DESIGN ADVISORY BOARD Tuesday, September 22, 2015 at 3:00 PM Conference Room 12, City Hall, Burlington, VT Amended Agenda

TO: Design Advisory Board
FROM: Scott Gustin
DATE: September 22, 2015
RE: 16-0209CA, 3174 North Avenue

Request: Construct new single family home on existing footprint.

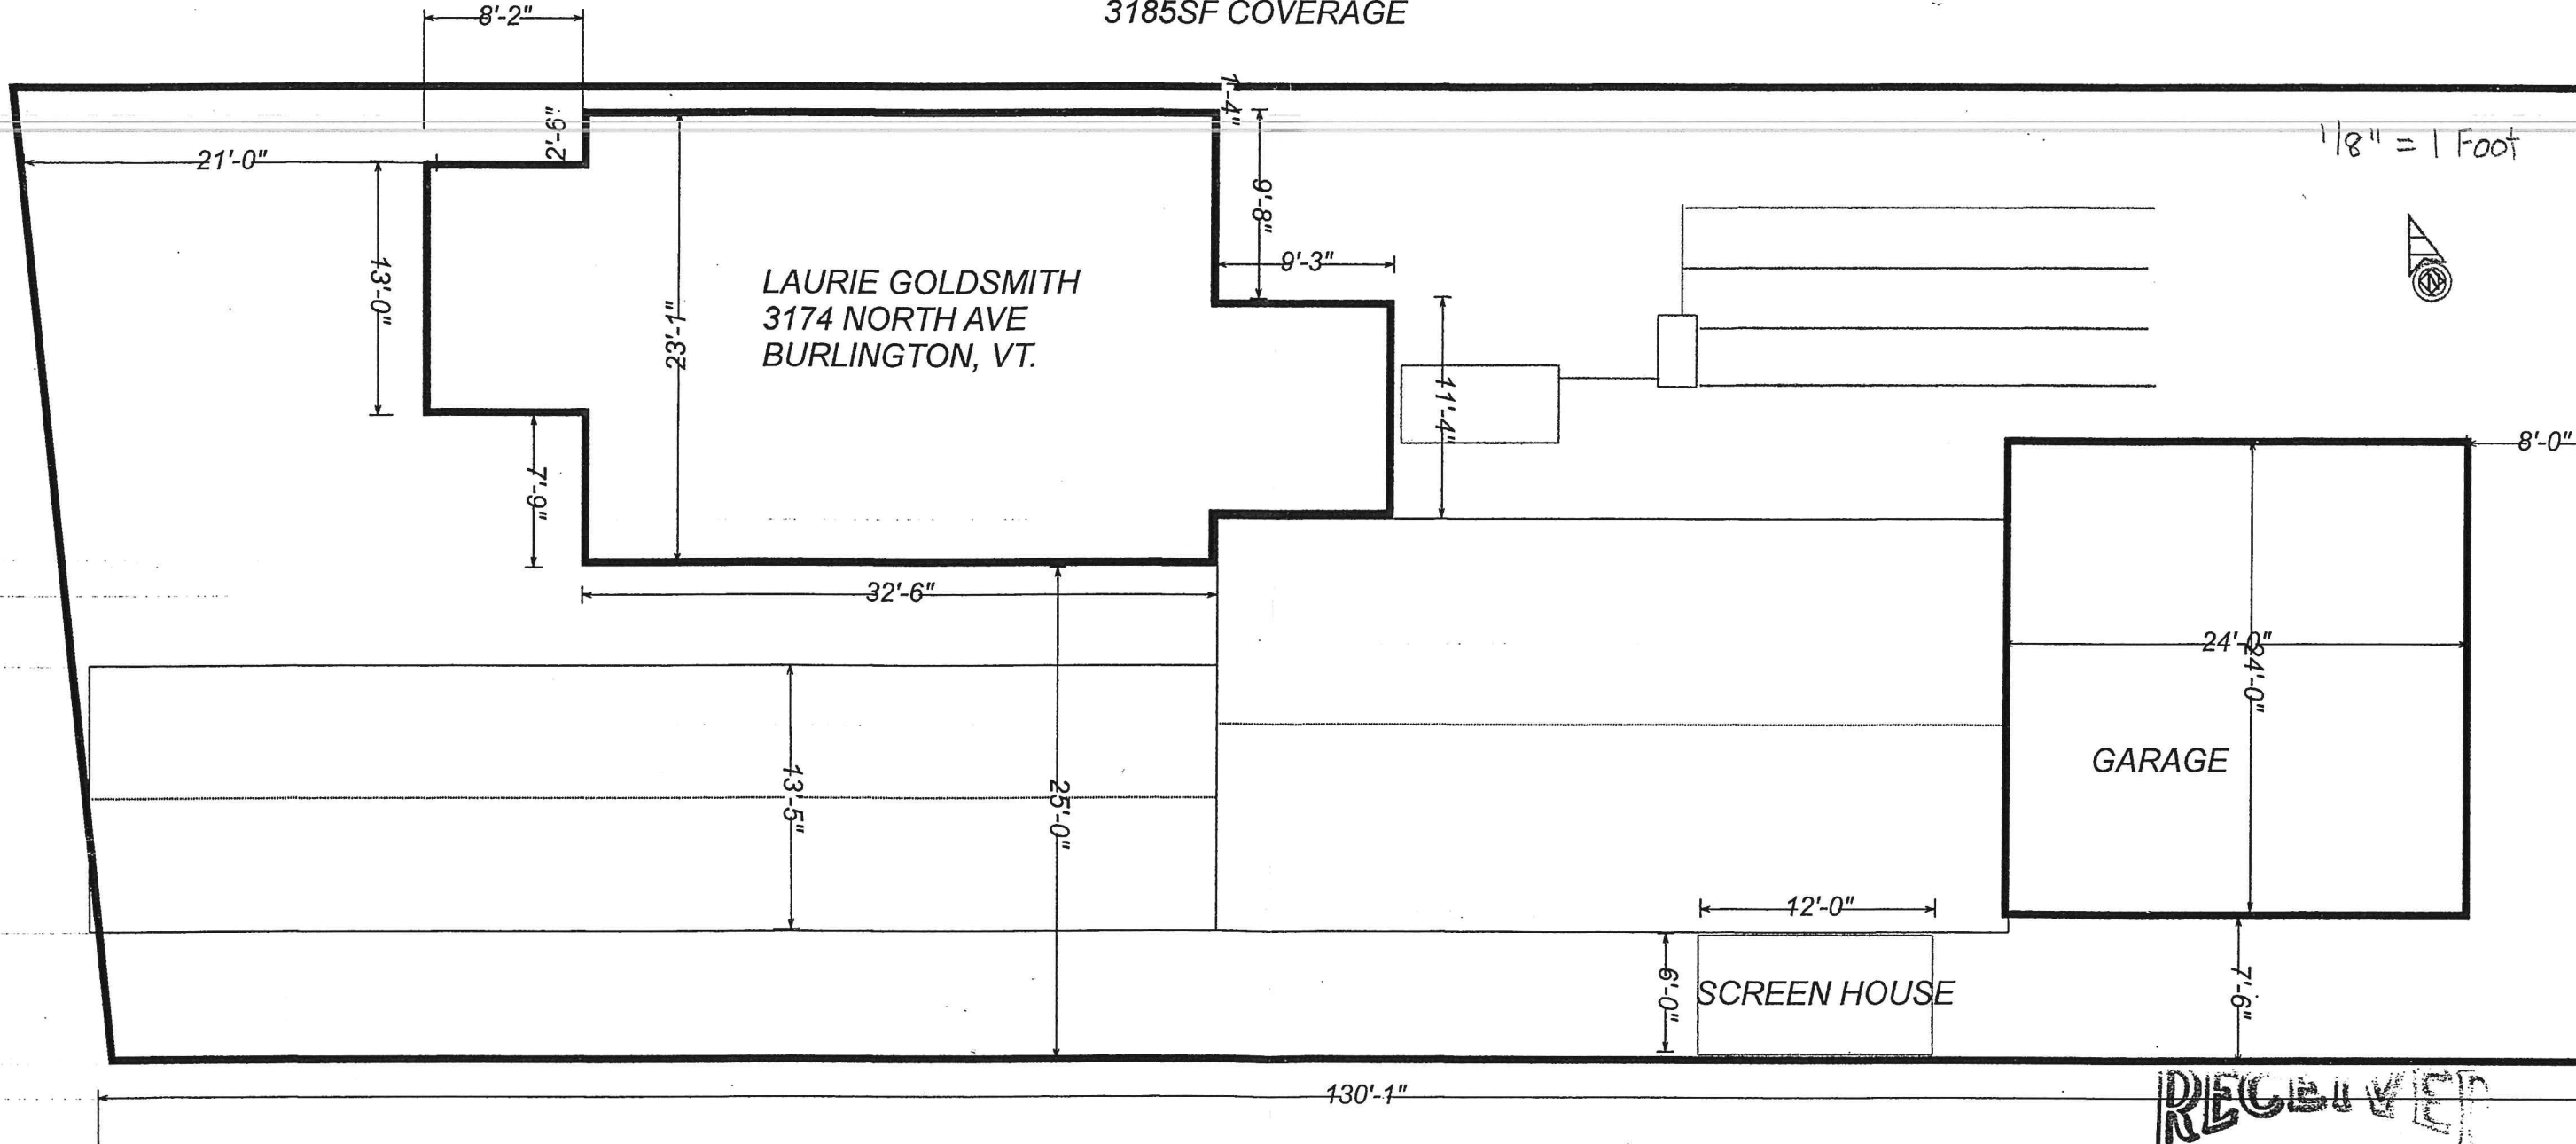
The location of the new home will match that of the previous home. As proposed, the front door faces south towards the driveway. No door faces the road. This criterion requires that the front entry face the street. The proposed home must be modified accordingly. It must have a front door facing North Avenue. Retention of a doorway facing the driveway is acceptable. Note that the cardinal points (north, south, etc.) are not noted on the elevation plans and must be.

As noted previously, the proposed home has no front entry facing the road and must. Revised project plans are needed. As proposed, there are no large blank walls or expanses of roof. A small blank wall faces away from the street.

A single revised elevation drawing has been provided and notes vinyl siding with fiber cement "shakes" on the gable ends. Vinyl windows will be installed throughout. The proposed siding and window materials are acceptable for this new construction. No roofing materials are noted, and details such as corner boards, foundation lines, and entry steps are missing. More detailed project plans are required.

1. Revise site plan to depict doorway landing and existing/proposed landscaping.
2. Provide cutsheets for exterior lighting.

6625 SF LOT
3185SF COVERAGE

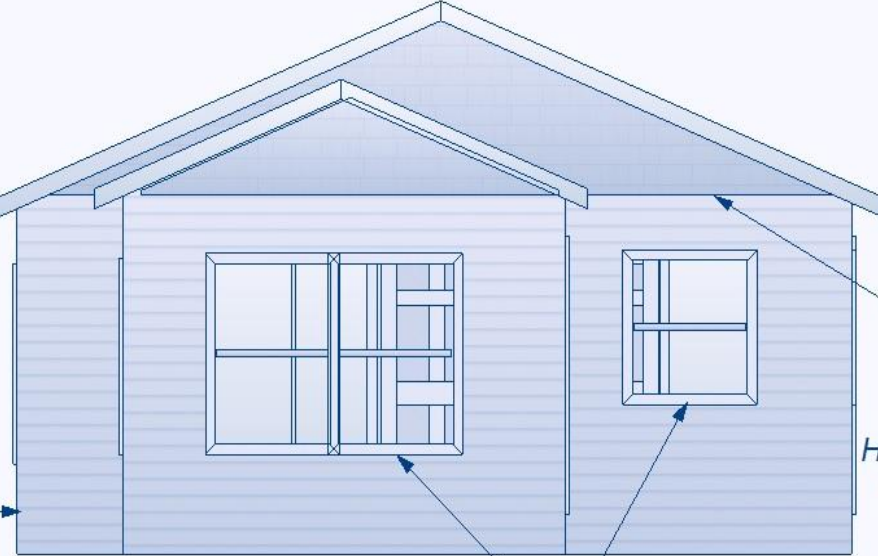
There is no public sidewalk along this portion of North Avenue, therefore a walkway from the front entrance to the public sidewalk is not required. A front walkway to the road is, nevertheless, recommended. There is no stair or landing in front of the doorway. Presumably, one will be installed. It must be included in the project plans.

No landscaping is depicted on the site plan. At least a basic landscaping plan is needed. A row of shrubs or similar plantings along the wetland border is advisable. Doing so would provide a barrier of sorts between the wetland and the developed portions of the property. No new fencing is proposed.
